Aeronautical Study No.
2016-WTE-6204-OE
Prior Study No.
2014-WTE-5439-OE

**** MARKING & LIGHTING RECOMMENDATION ****

Structure:	Lighting Study for Wind Turbine Wind Turbine AWE 1
Location:	Antrim, NH
Latitude:	43-04-03.41N NAD 83
Longitude:	72-00-28.14W
Heights:	1431 feet site elevation (SE) 489 feet above ground level (AGL) 1920 feet above mean sea level (AMSL)

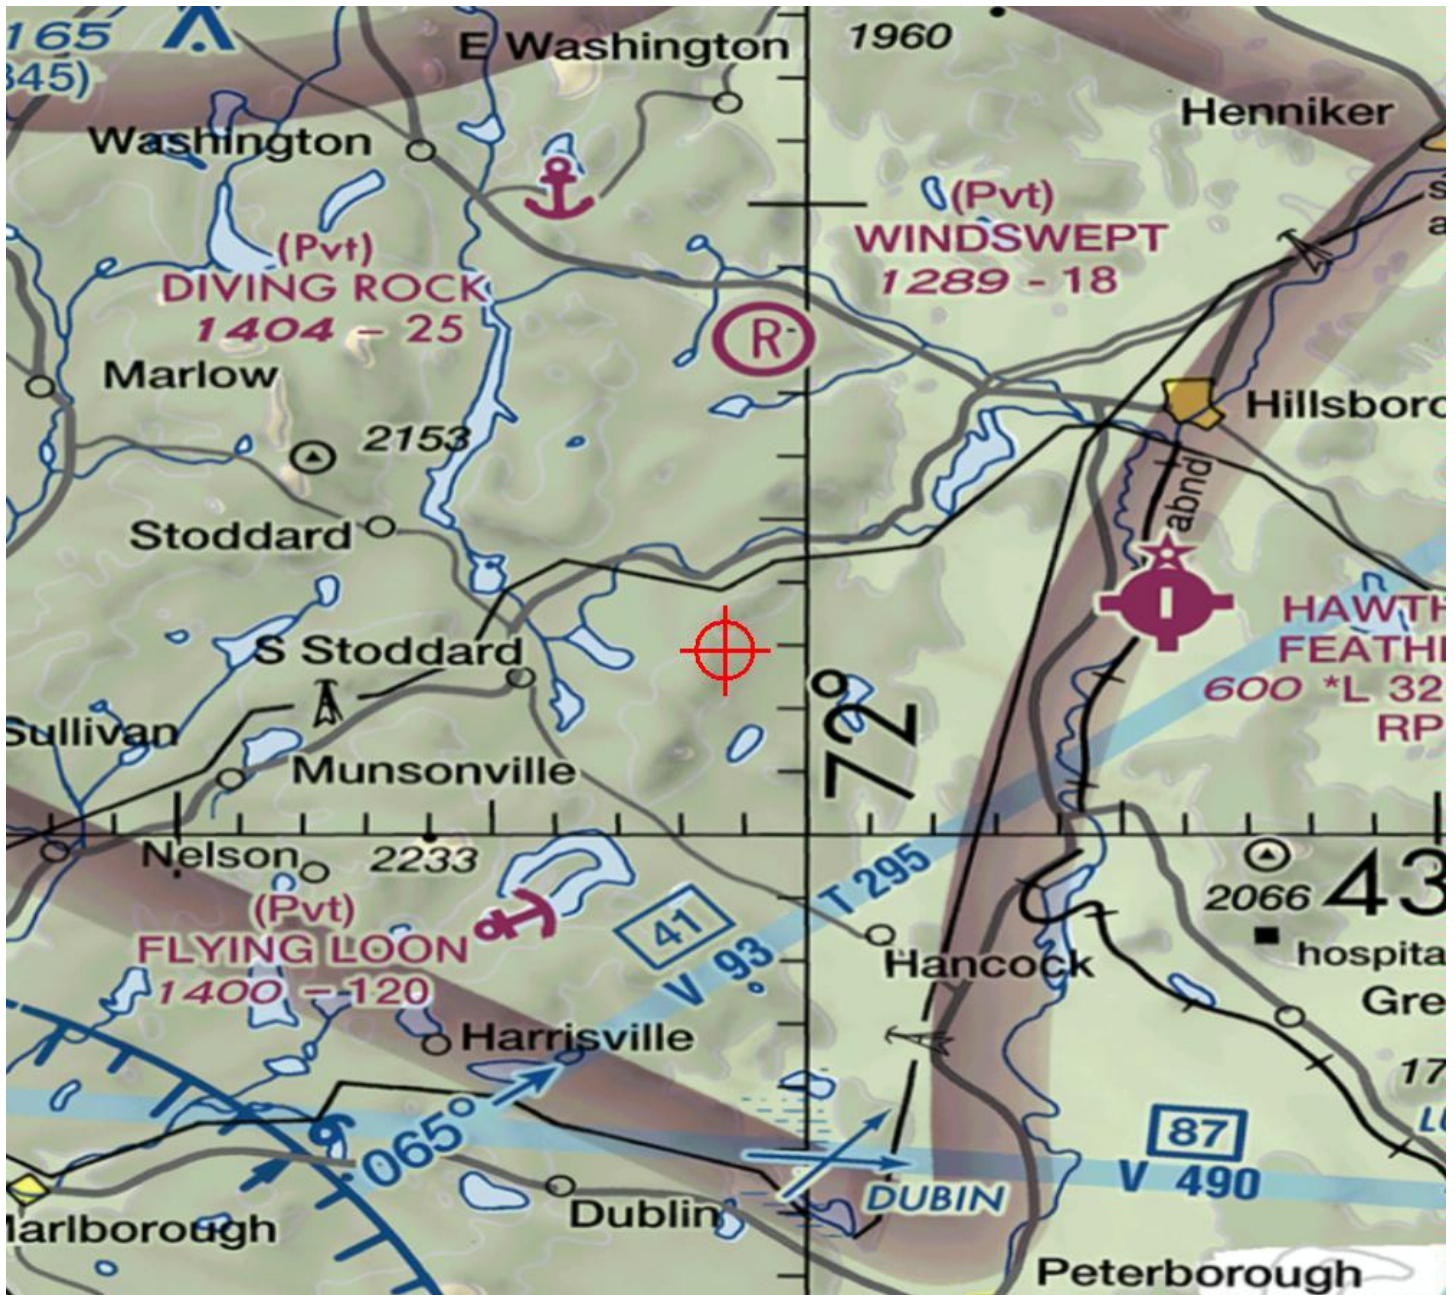
Based on this evaluation, we have no objection to the change provided the structure is marked/lighted in accordance with FAA Advisory Circular 70/7460-1, L Change 1 , Obstruction Marking and Lighting, white paint/synchronized red lights - Chapters 4,12&13(Turbines).

Your request for consideration to utilize an Aircraft Detection Lighting System to operate the recommended lighting is approved provided that the equipment meets established technical standards.

In order to ensure proper conspicuity of turbines at night during construction, all turbines should be lit with temporary lighting once they reach a height of 200 feet or greater until such time the permanent lighting configuration is turned on. As the height of the structure continues to increase, the temporary lighting should be relocated to the uppermost part of the structure. The temporary lighting may be turned off for periods when they would interfere with construction personnel. If practical, permanent obstruction lights should be installed and operated at each level as construction progresses. An FAA Type L-810 steady red light fixture shall be used to light the structure during the construction phase. If power is not available, turbines shall be lit with self-

contained, solar powered LED steady red light fixture that meets the photometric requirements of an FAA Type L-810 lighting system. The lights should be positioned to ensure that a pilot has an unobstructed view of at least one light at each level. The use of a NOTAM (D) to not light turbines within a project until the entire project has been completed is prohibited.

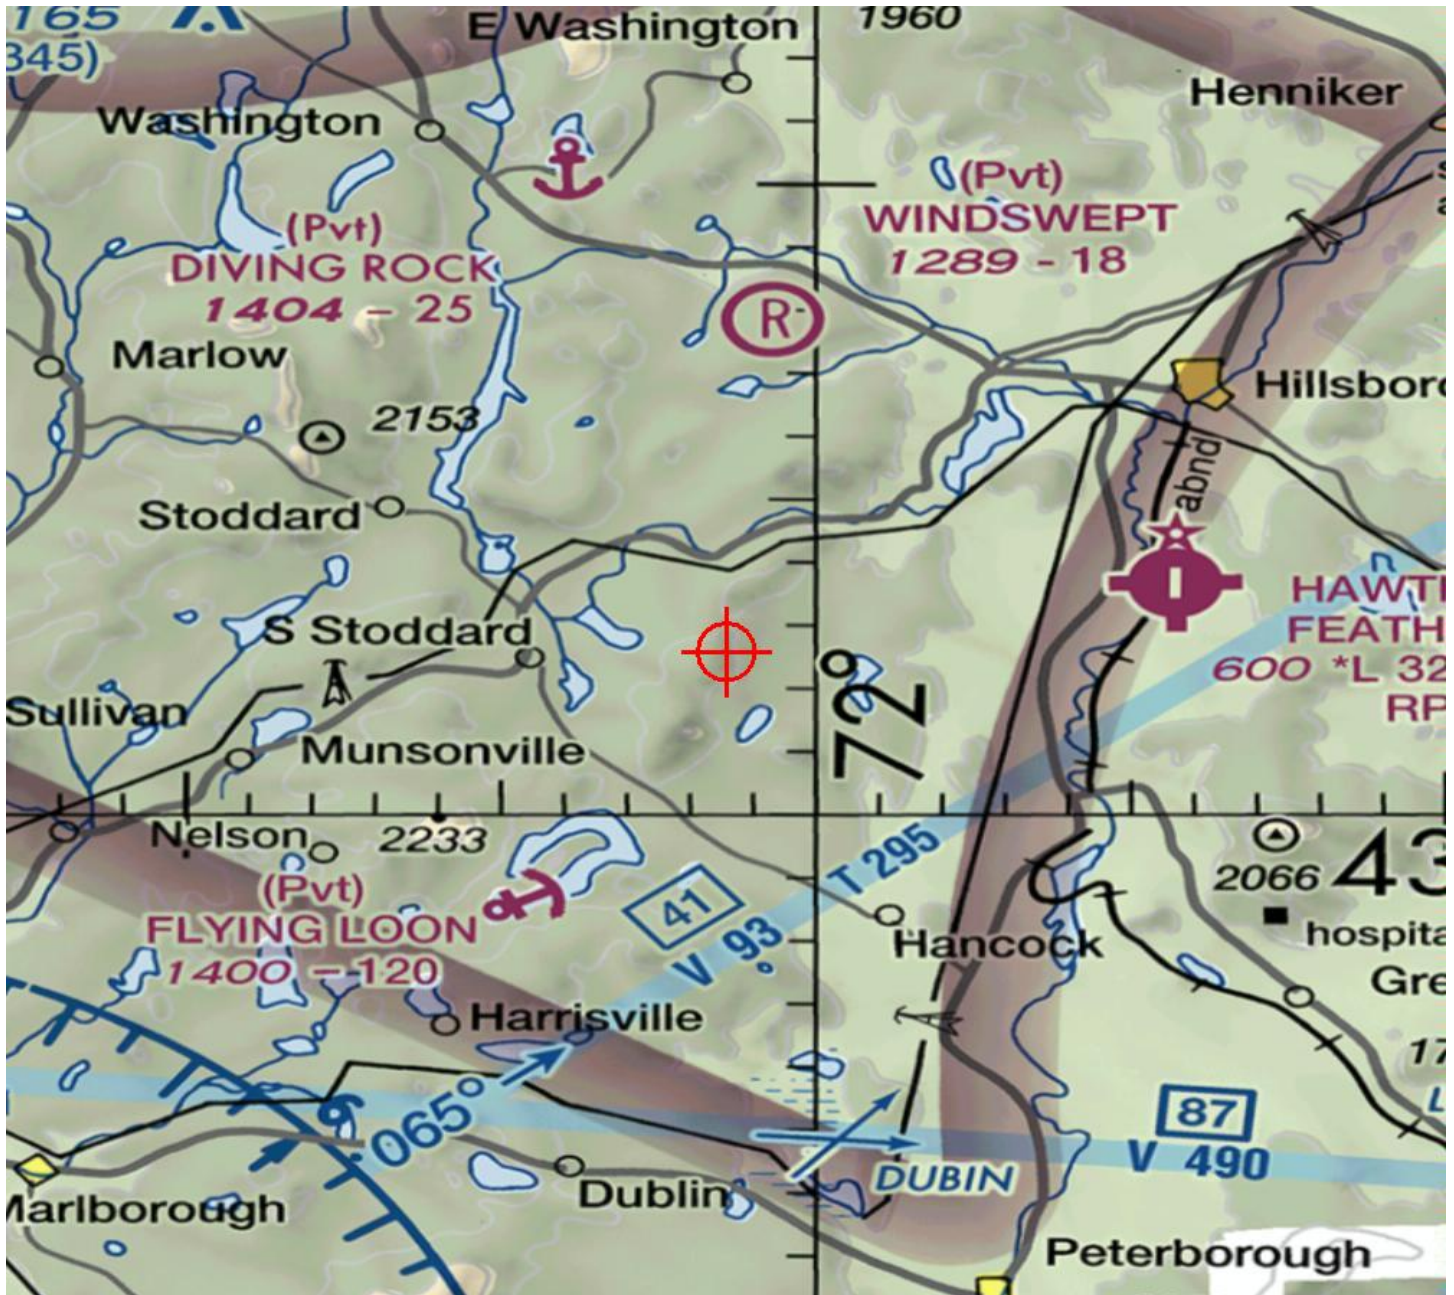
Based on this evaluation, we have no objection to the change provided the structure is marked/lighted in accordance with FAA Advisory Circular 70/7460-1, L Change 1 , Obstruction Marking and Lighting, white paint/synchronized red lights - Chapters 4,12&13(Turbines).

Your request for consideration to utilize an Aircraft Detection Lighting System to operate the recommended lighting is approved provided that the equipment meets established technical standards.

In order to ensure proper conspicuity of turbines at night during construction, all turbines should be lit with temporary lighting once they reach a height of 200 feet or greater until such time the permanent lighting configuration is turned on. As the height of the structure continues to increase, the temporary lighting should be relocated to the uppermost part of the structure. The temporary lighting may be turned off for periods when they would interfere with construction personnel. If practical, permanent obstruction lights should be installed and operated at each level as construction progresses. An FAA Type L-810 steady red light fixture shall be used to light the structure during the construction phase. If power is not available, turbines shall be lit with self-

contained, solar powered LED steady red light fixture that meets the photometric requirements of an FAA Type L-810 lighting system. The lights should be positioned to ensure that a pilot has an unobstructed view of at least one light at each level. The use of a NOTAM (D) to not light turbines within a project until the entire project has been completed is prohibited.
